NORTH CENTRAL HIGH SCHOOL, PHASE 2

Addendum 2

CD
S3.05

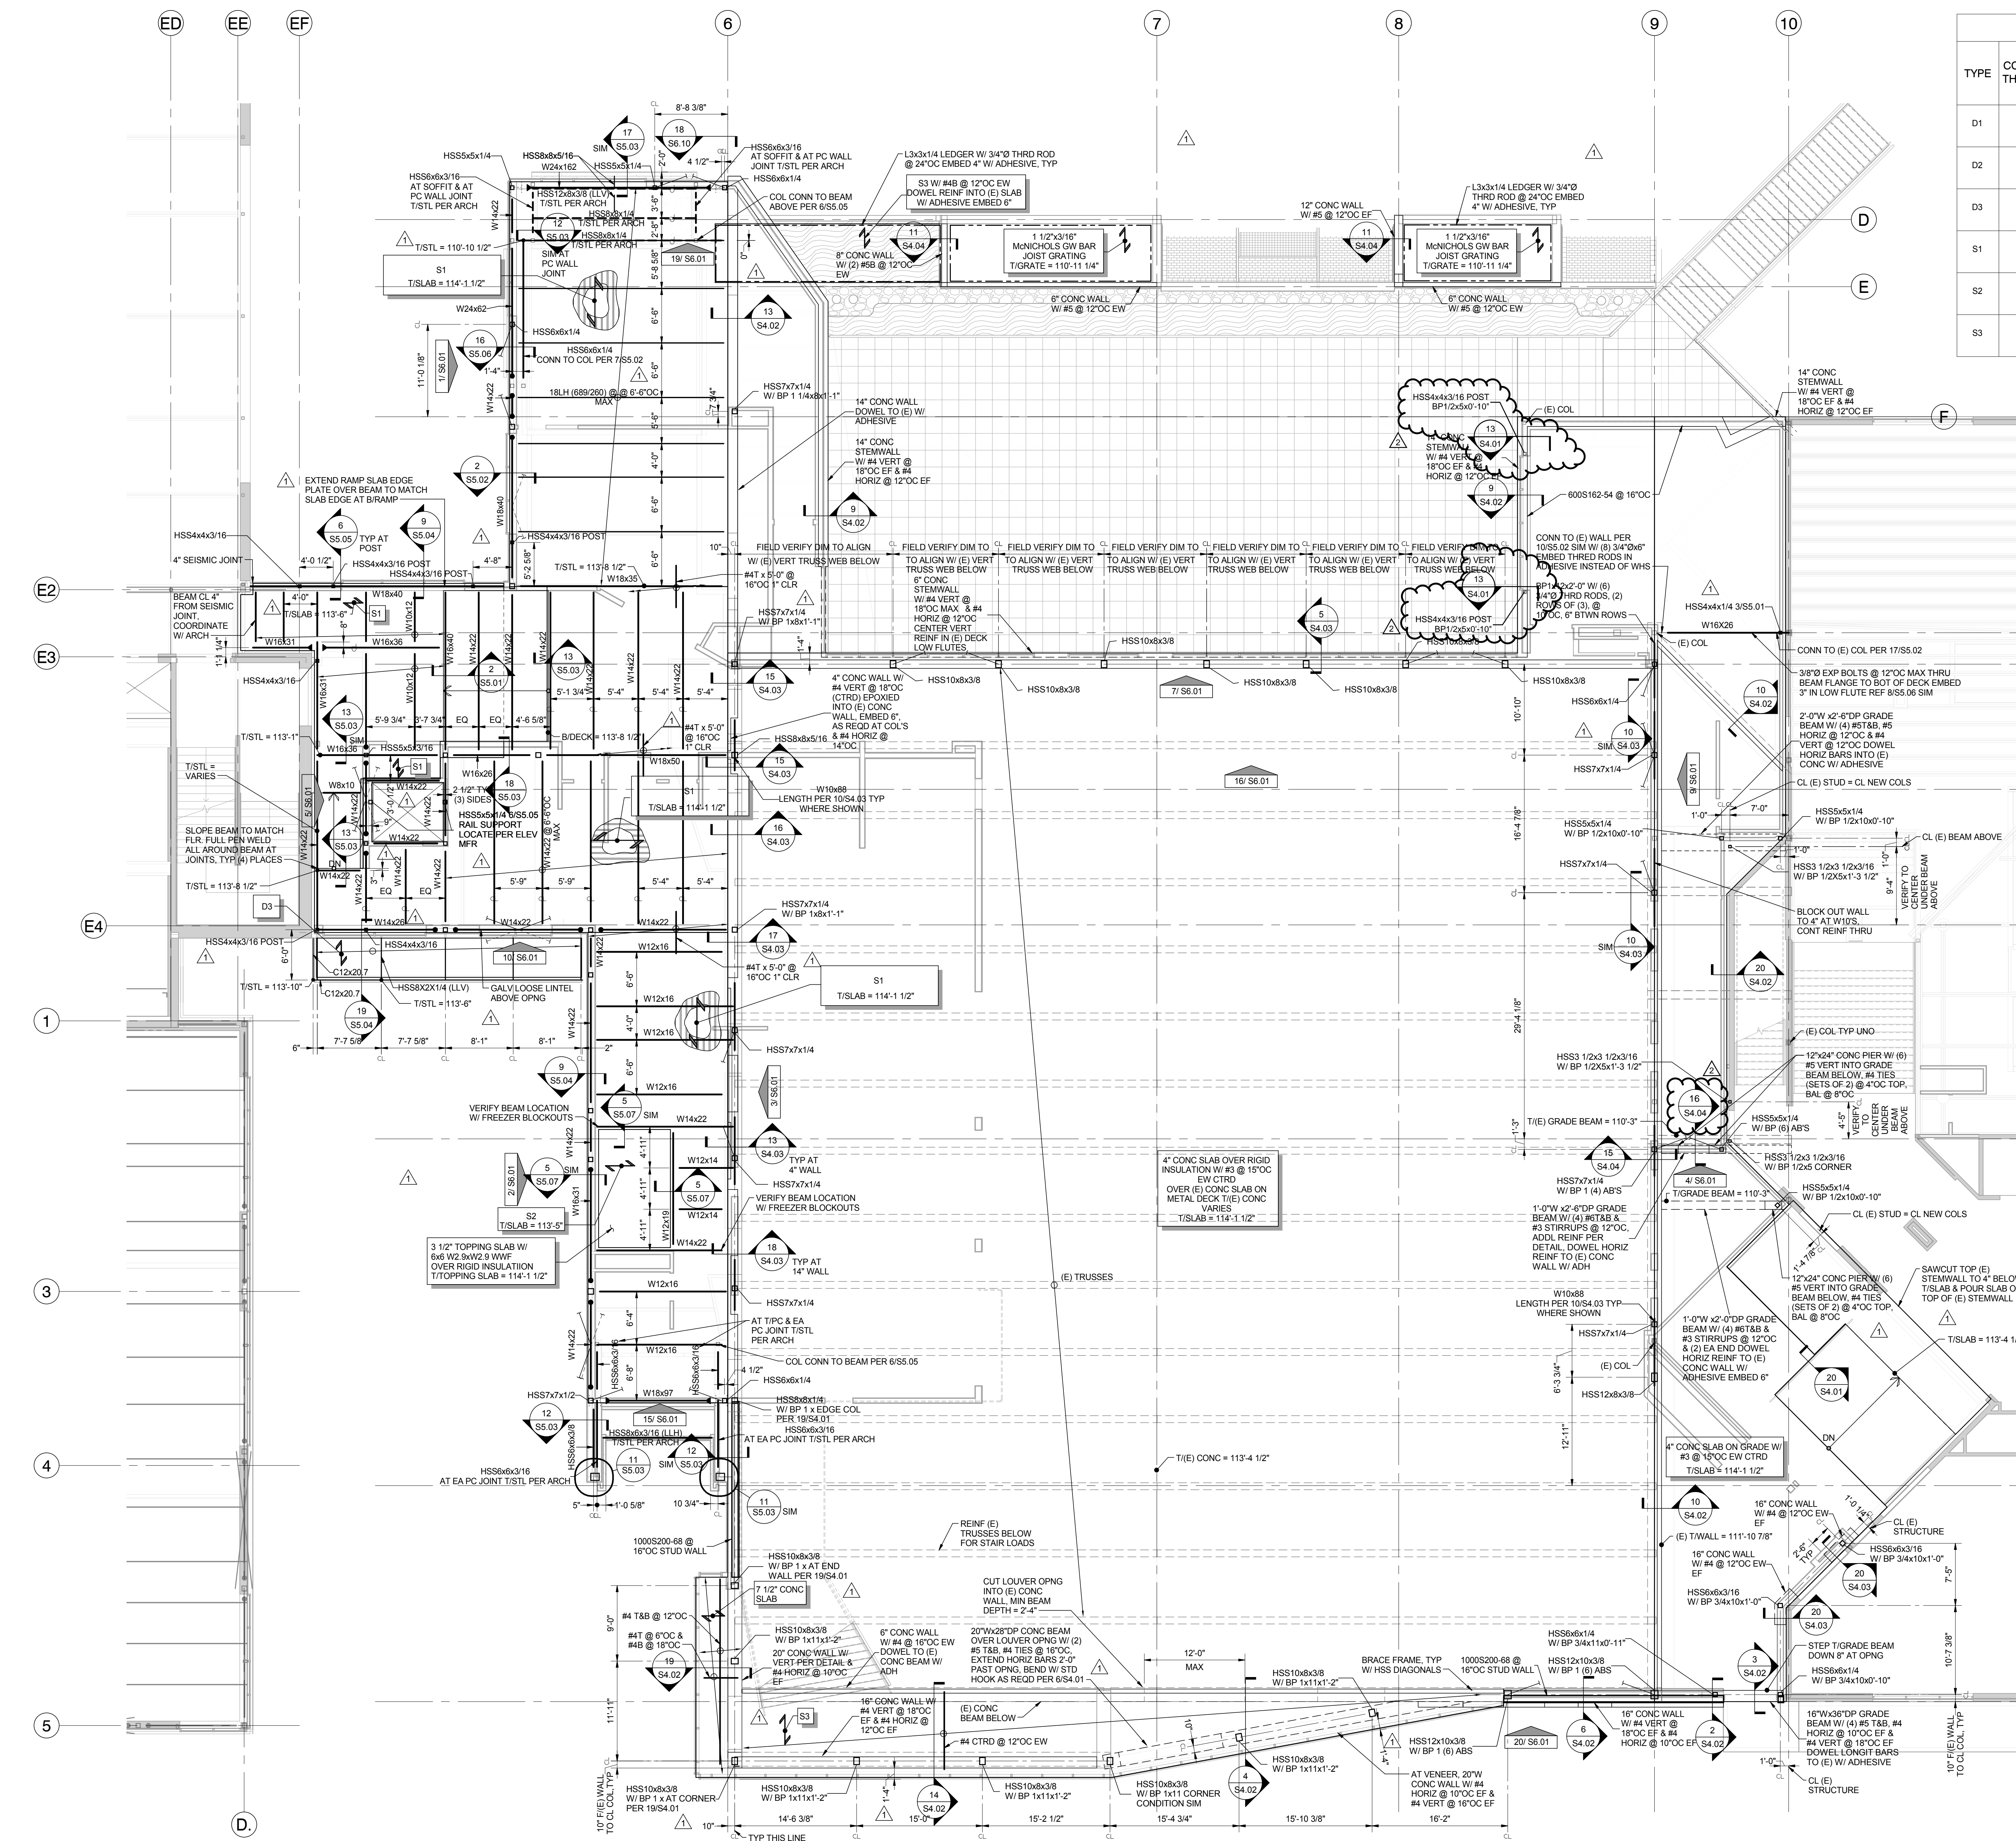
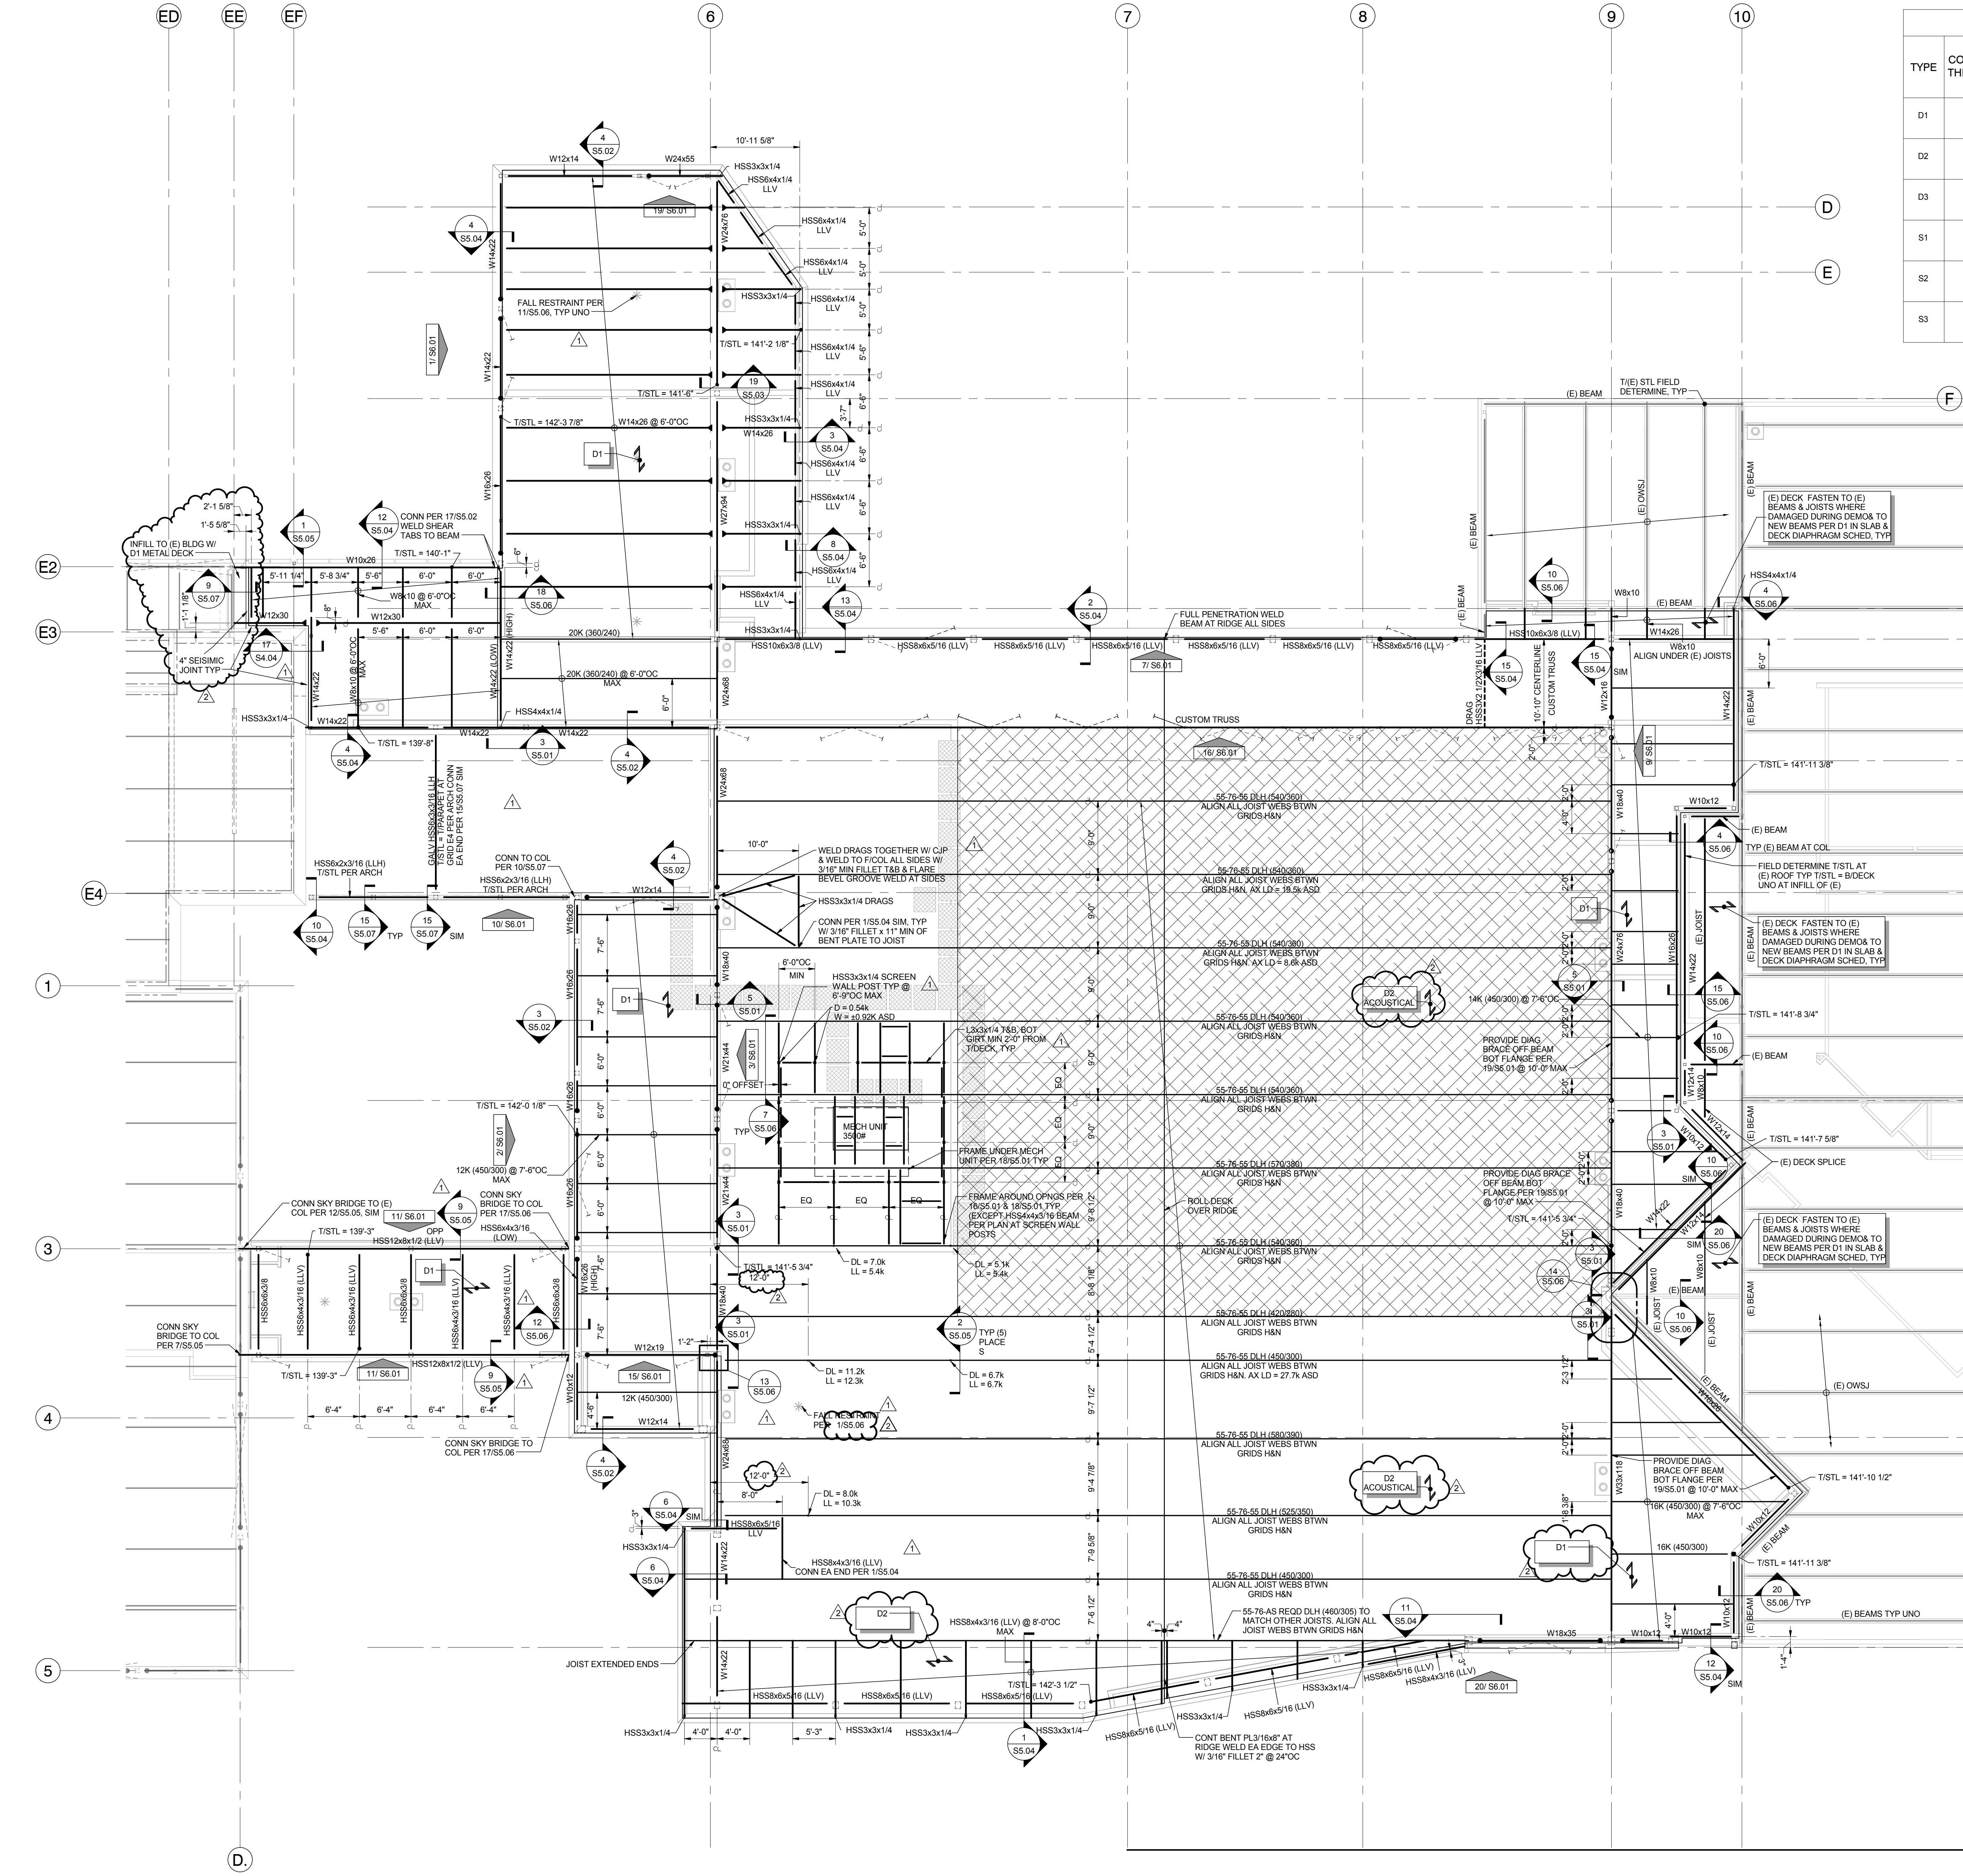
SHEET S3.05, ROOF LEVEL FRAMING PLAN:

CHANGE: See clouded items typical. Not all items are identified in the text below. Some items are detail reference coordination and added or revised dimensions.

ADD: Deck infill at east seismic joist, decking callouts.

REVISE: Fall restraint detail reference
